**Economic Commission for Europe****Administrative Committee for the TIR Convention, 1975****Technical Implementation Body****Fifth session**

**eTIR conceptual, functional and technical specifications:****Version 4.4****Concrete amendment proposals****Note by the secretariat****I. Background and mandate**

Figure I  
**Current customs management of guarantees class diagram**

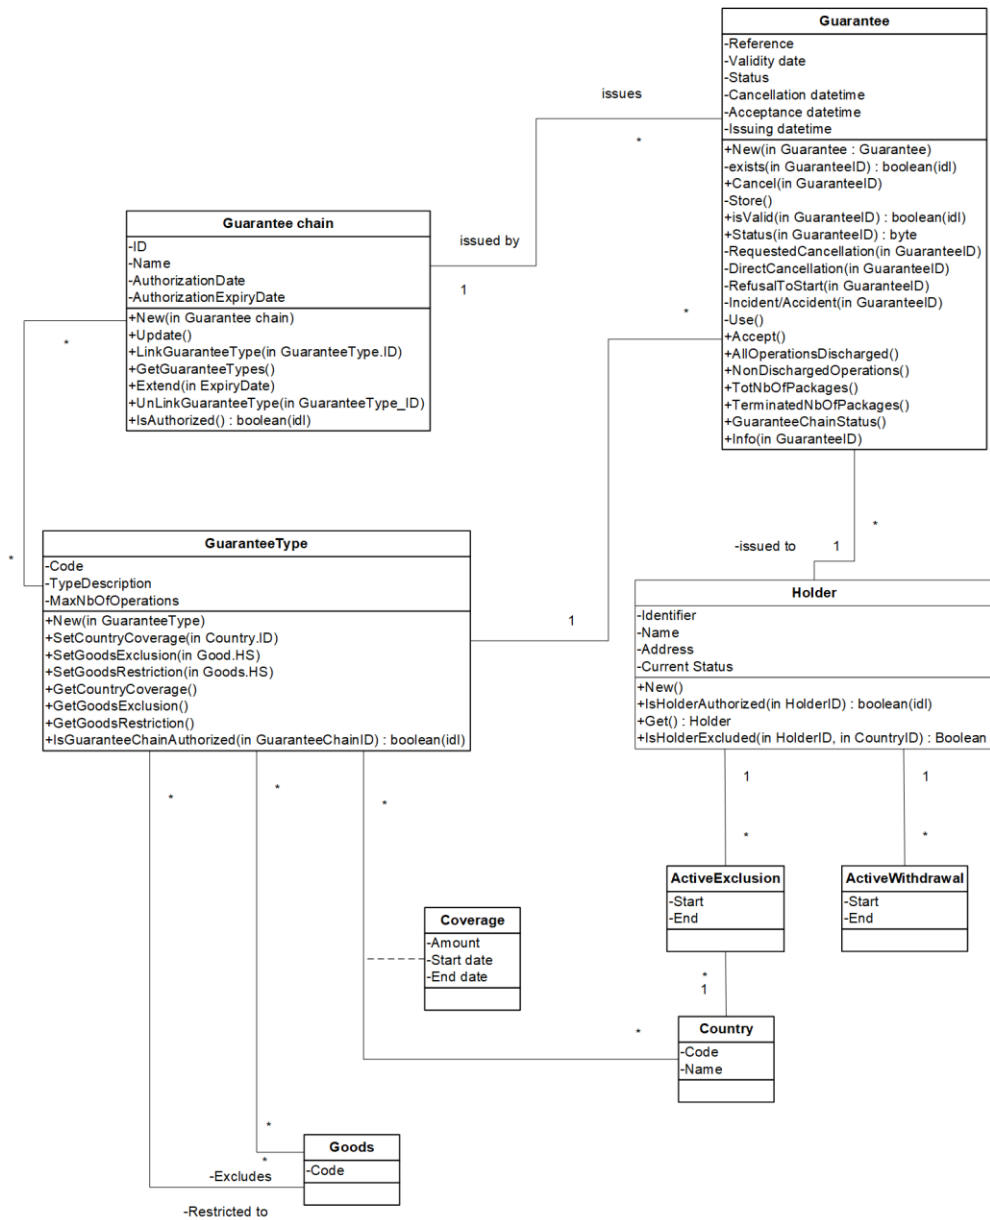
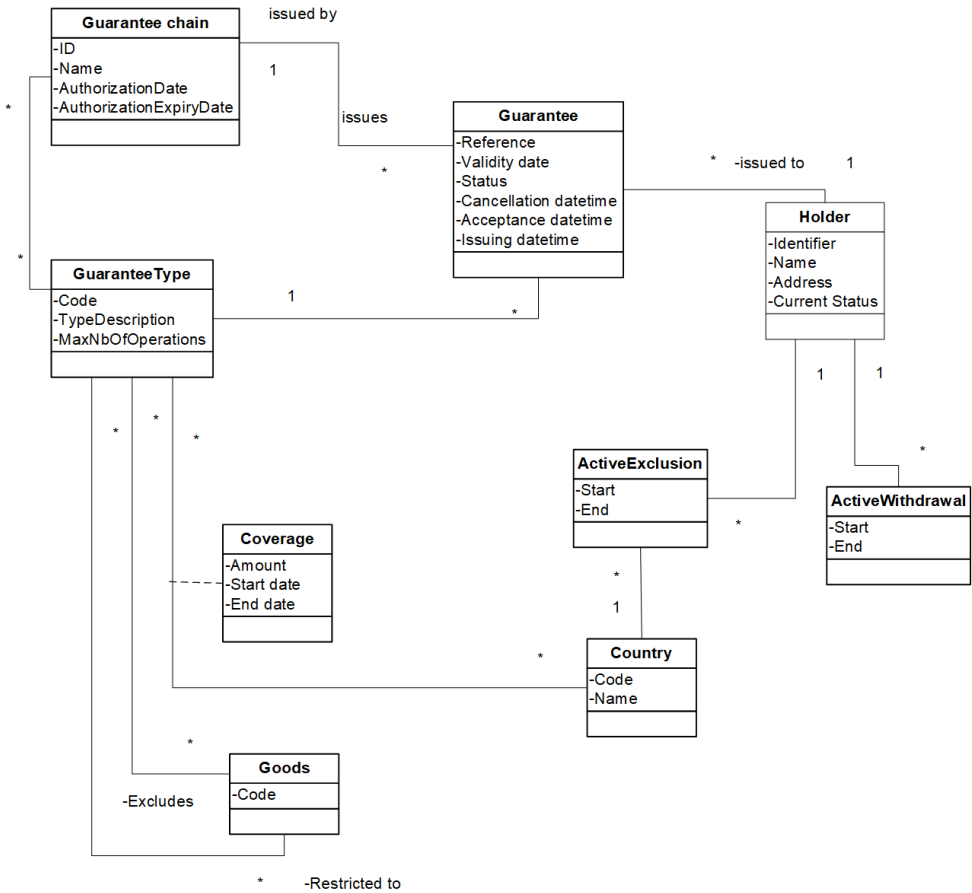
23. UML Class diagrams used in version 4.3 of the eTIR functional specifications contain not only classes, their relationships and their attributes, but also a set of methods that were aimed at facilitating the development of the eTIR international system. As such, these methods have little to no use for the countries that wish to amend their customs system to implement the eTIR procedure. Figures I and II below show the difference between the current and the simplified version of the customs management of guarantees class diagram (Figure 1.19 of the eTIR functional specifications).

24. At its third session, TIB agreed to simplify the class diagrams.

Figure V  
**Business Process Diagram for the Start TIR operation process**

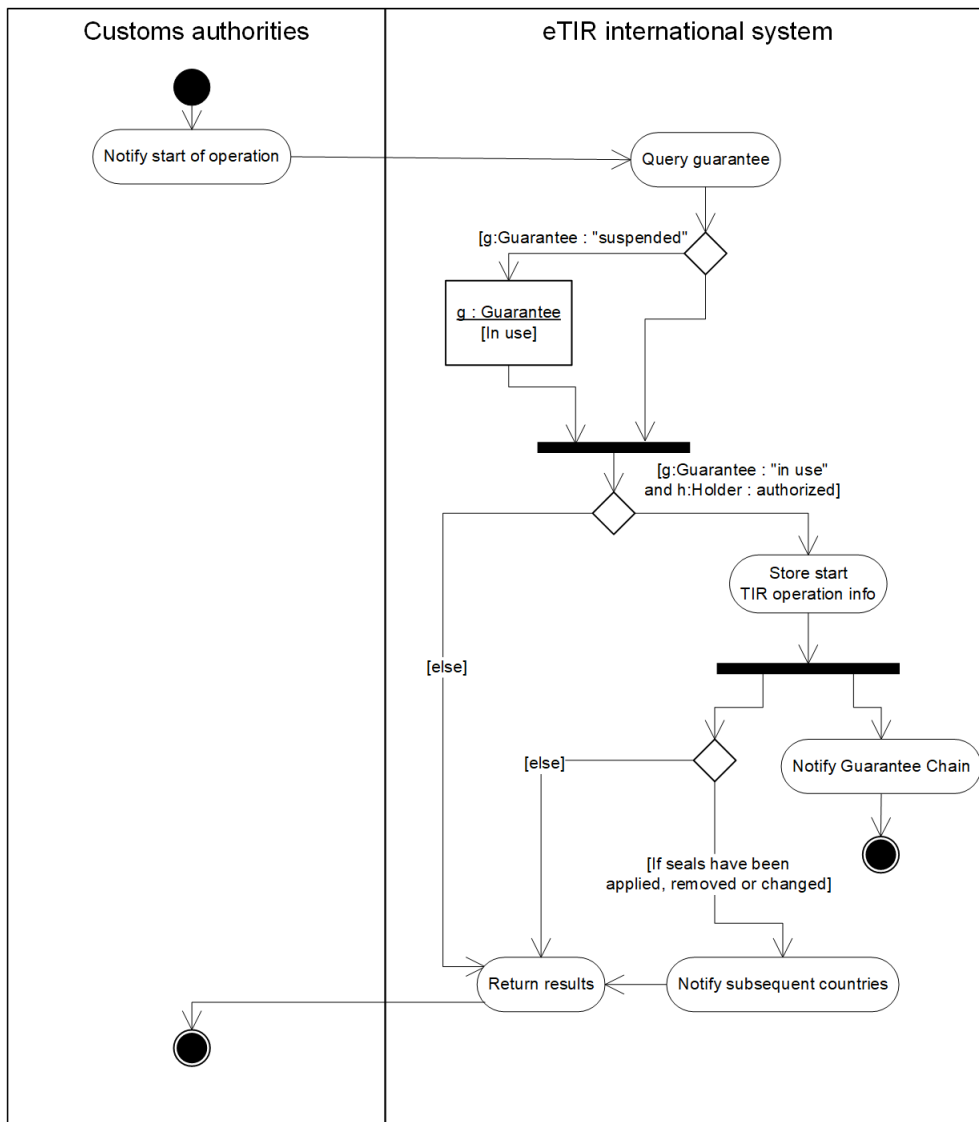
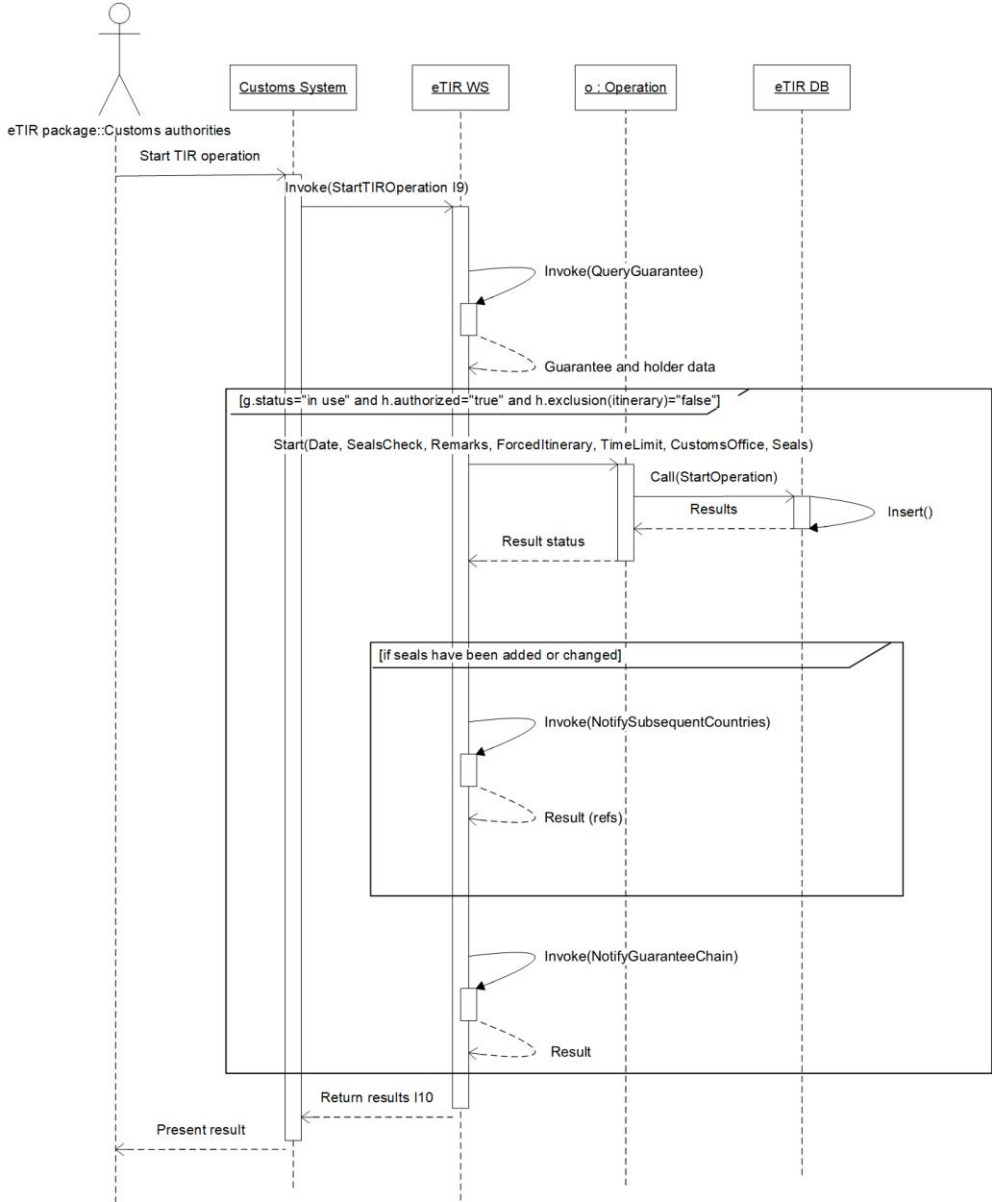
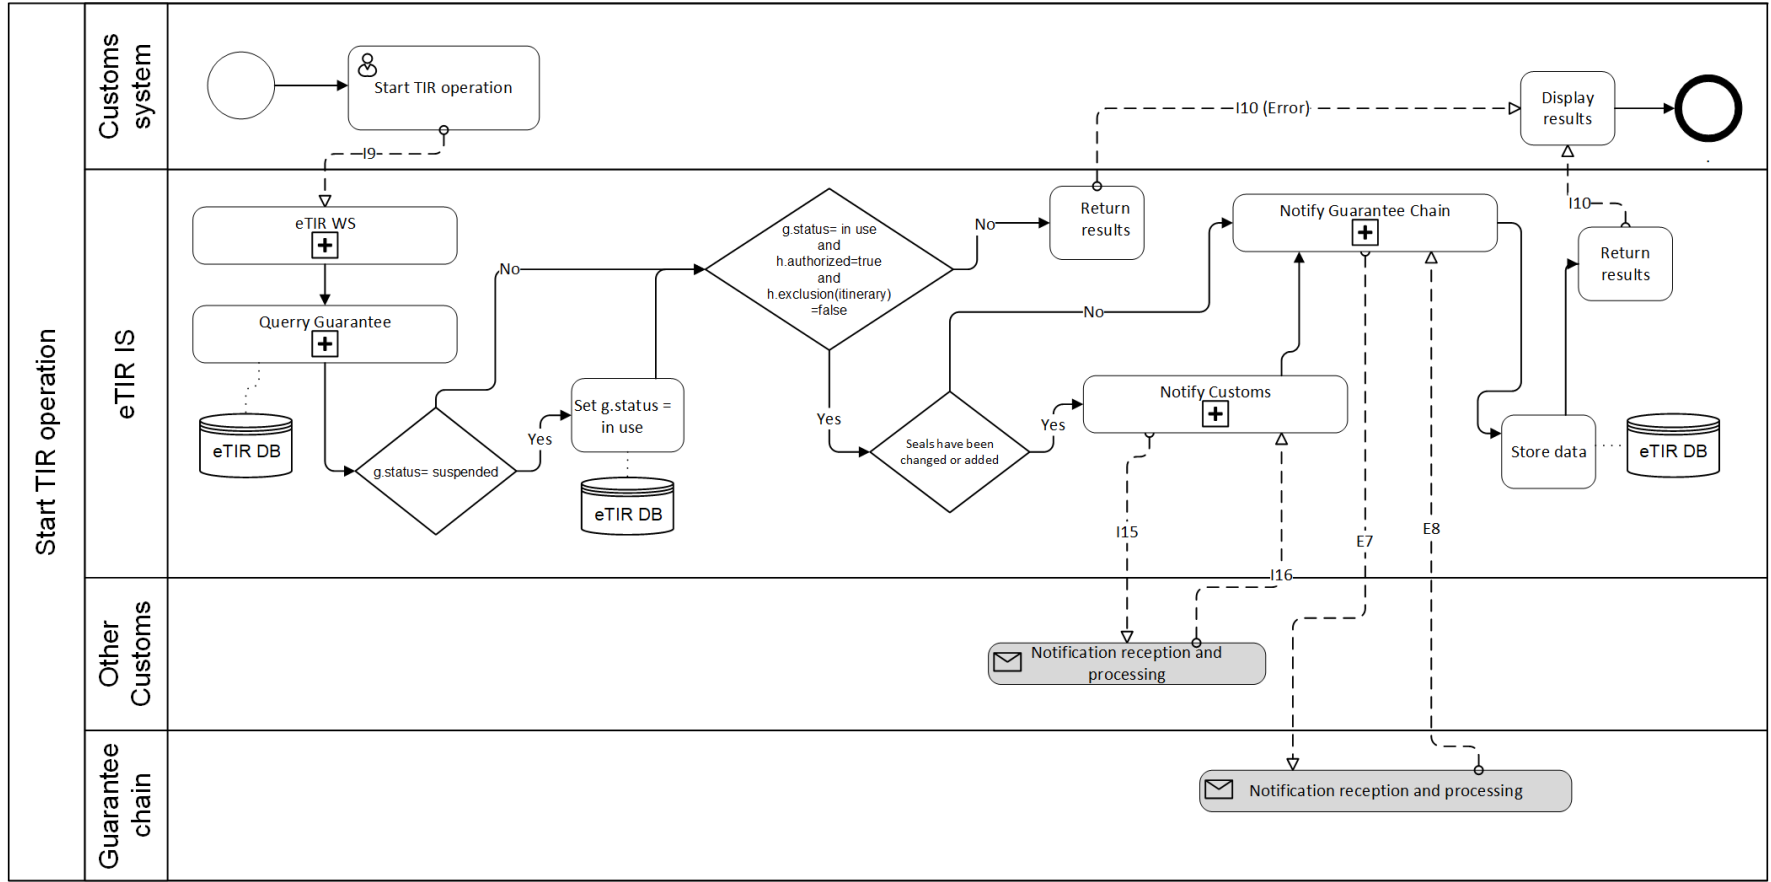
25. In version 4.3 of the eTIR specifications, in line with the Unified Modelling Methodology (UML) chosen originally for the eTIR project, the modelling of processes is done using UML activity and sequence diagrams. In recent years, the business process model and notation (BPMN) has gained in popularity in both the business and Information and Communication Technologies (ICT) communities and is, therefore, better understood by laymen and experts alike. With that in mind, TIB might wish to consider if, in version 4.4 of the eTIR specifications, BPMN should replace the activity and sequence diagrams used in version 4.3. Figures III, IV and V below show the UML activity diagram (Figure 12 of the eTIR concepts), UML sequence diagram (Figure 1.9 of the eTIR functional specifications) and the Business Process Diagram for the Start TIR operation process.

26. At its third session, TIB agreed to replace the existing diagrams (in Unified Modelling Methodology – UML) in the conceptual and functional specifications with the newly proposed diagrams (in Business Process Model and Notation – BPMN), in line with the examples above.
